932 PITTWATER ROAD DEE WHY

DEE WHY RSL CLUB

Design Statement

The proposed amendments to the approved DA2017/0244 are concerned with minor improvements to the original design and they do not affect the overall image of the building nor do they affect the surrounding properties. The changes submitted for approval are simply the direct result of the design development process, achieving a reduced environmental impact in terms of shadow cast and view corridor.

Figure 1a. Revised design: plant room under 12m height plane

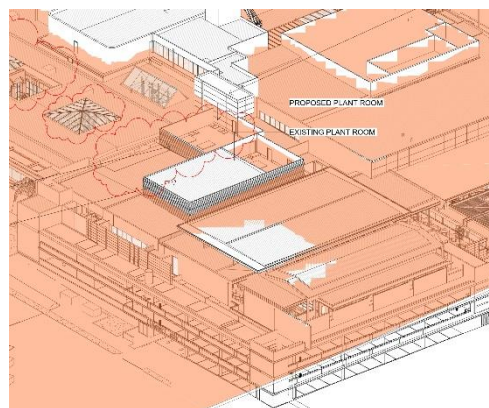
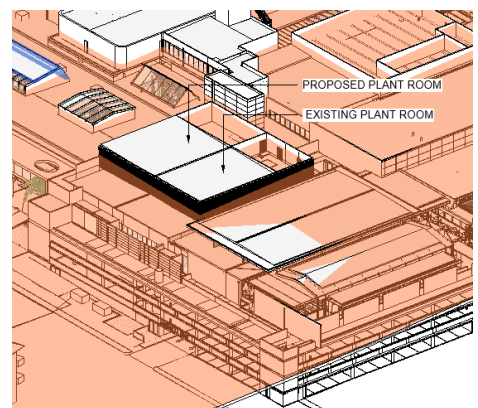
-Plant Room

The size of the modified plant room is matching the area requirements of hosted services and the reduced height wall around these services has led to the plantroom now complying with the 12m height plane as outlined in the DCP.

Figure 2a. Revised design: all skylights under 12m height plane

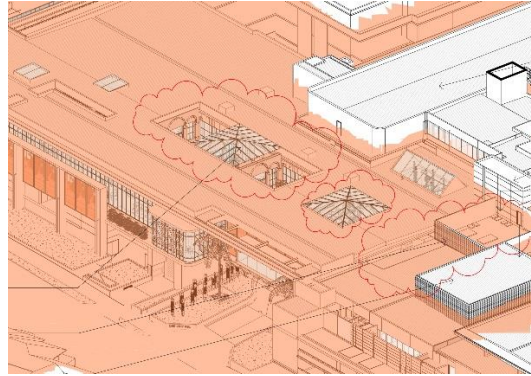
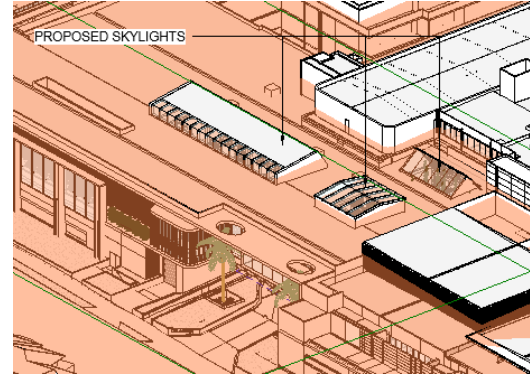
-Modified courtyard and skylights

The new layout of the courtyards and skylights above has been included to provide a more human scale in this part of the main trading floor. The new layout provides three separate courtyard areas, two external and one internal within the main food and beverage precinct. This is an important aspect of design as the main space achieves a certain degree of variety and becomes more clearly identifiable. All roof skylights are under the 12m height plane

Figure 3a. Revised design: extent of screens indicated with blue dashed line. Glass indicated with red dashed line

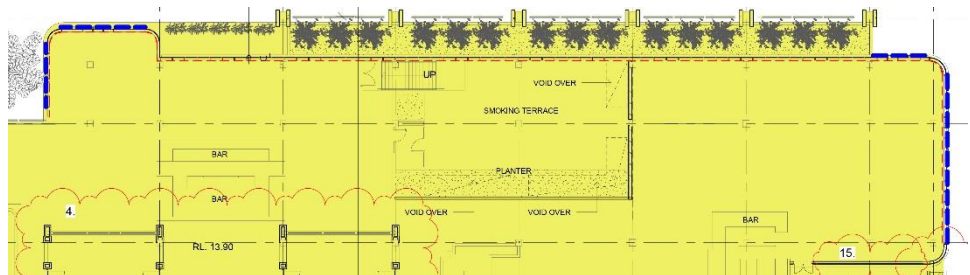
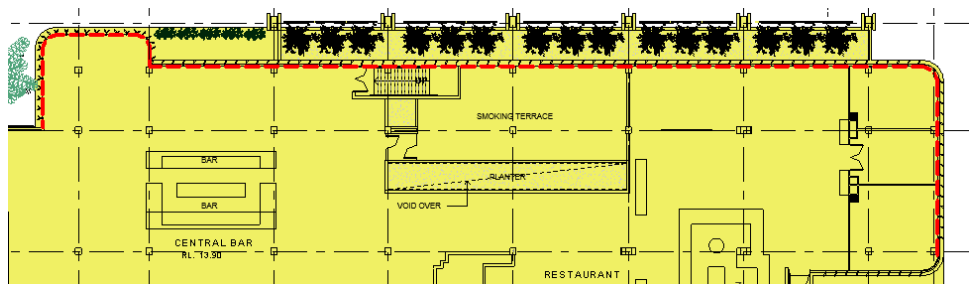
-Façade mullion blades

The mullion blades have been developed into a screen that creates a link between vertical mullions. The screens are intended to soften the overall impact of the façade as well as to accentuate specific areas described as urban activators in the DA design statement: the entrance and the southern corner.

Figure 6a. Revised design: set back wall shown in dashed blue line

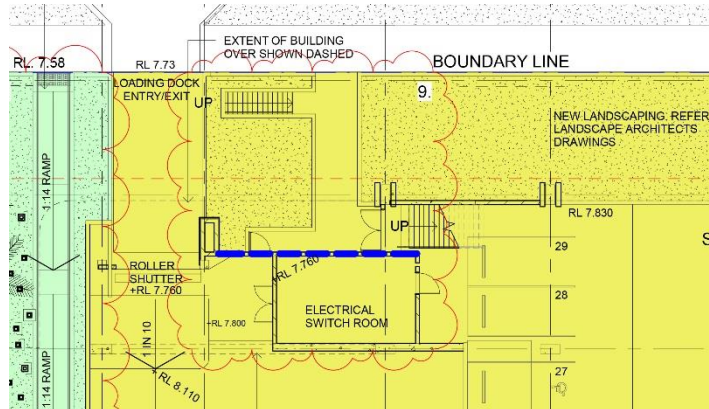
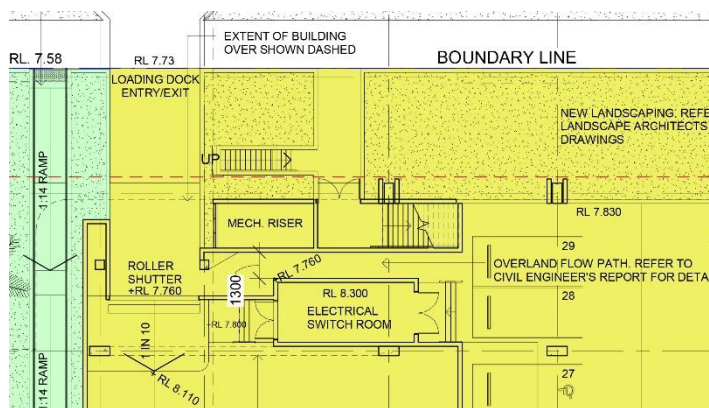
-Modified façade next to loading dock entrance

Due to mechanical riser no longer needed in this area as well as the change of location for the overflow path to the southern car park, the façade has been modified to reflect the new functional layout. The setback of the wall in this area also enhances the concept of the main entrance by adding a stronger shadow line under the cantilevered façade.

Figure 10. Median strip to vehicular entrance

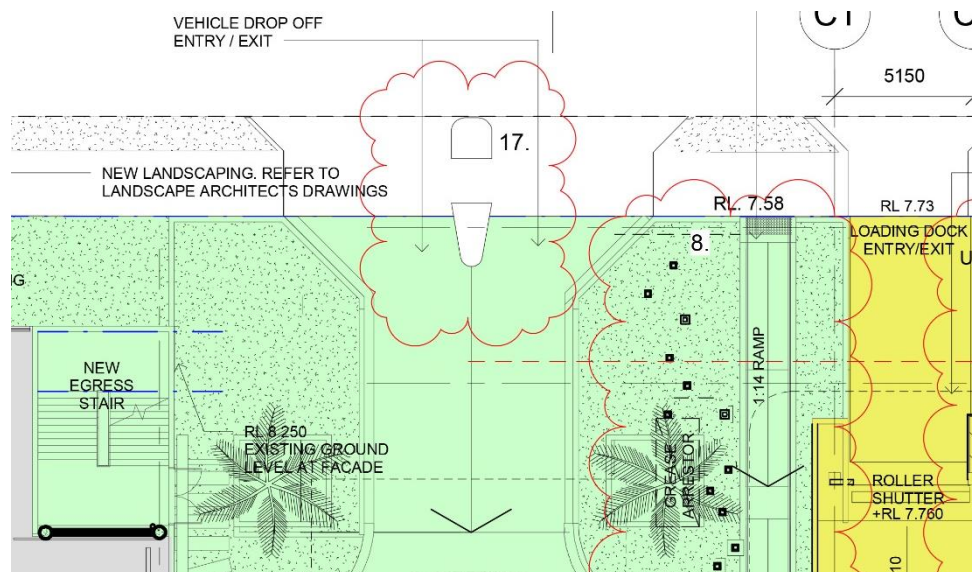
-Median strip to vehicular entrance

DA condition 23 states that a maximum entrance width of 8m is permissible at the main entrance of the club. To achieve this, a new median strip is proposed at the main vehicle entrance on the site. A refuge space of 1.5m between the entry and exit aisles which are both 5.73 m wide which is below the permissible 8 m.
